Application for Licence Amendment

Licence Number L9423/2024/1

Licence Holder Golden Grove Operations Pty Ltd

Premises Golden Grove Mine
YALGOO WA 6635

Figure 2: Tailings Deposition Design

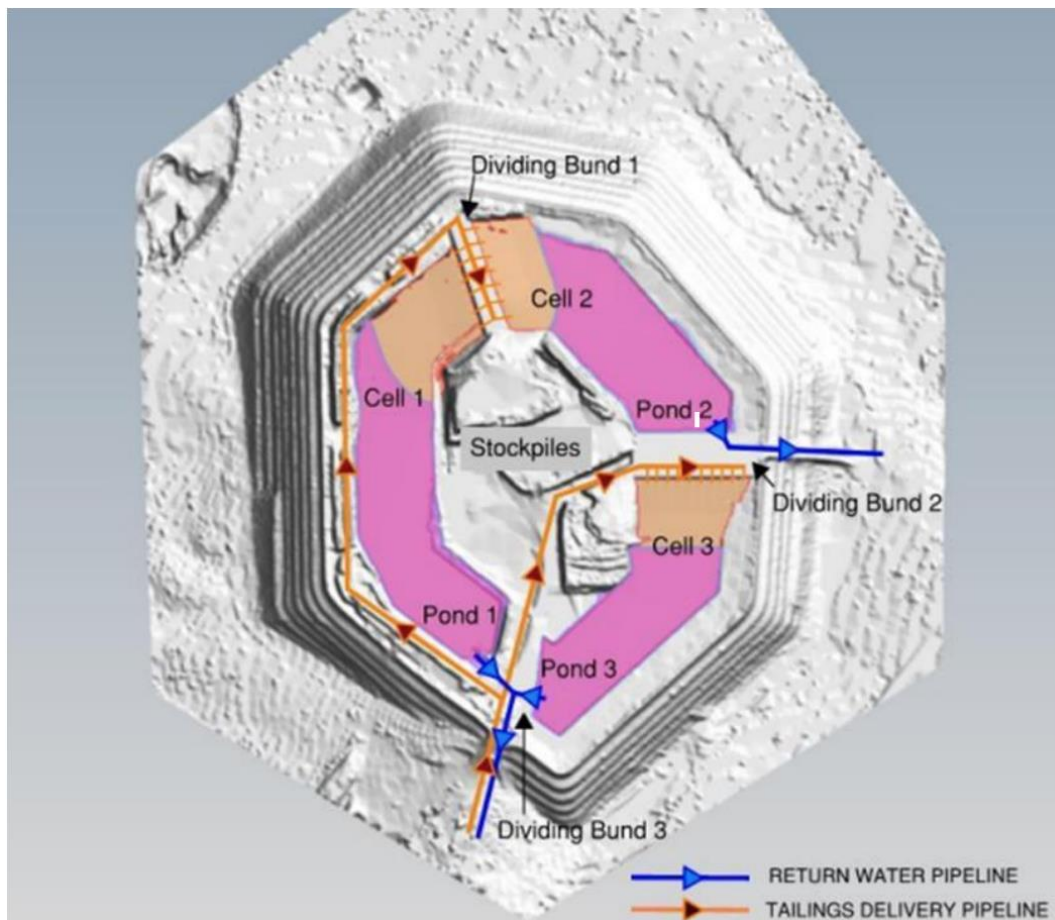
Tailings will enter TSF 2 via the highest point of the dividing bunds which will promote water return to the lowest points of the embankment. Cell 1 and Cell 2 will deposit from Dividing Bund 1, while Cell 3 will deposit from Dividing Bund 2. Corresponding water return ponds will form at Dividing Bunds 2 and 3 as shown in Figure 2 above.
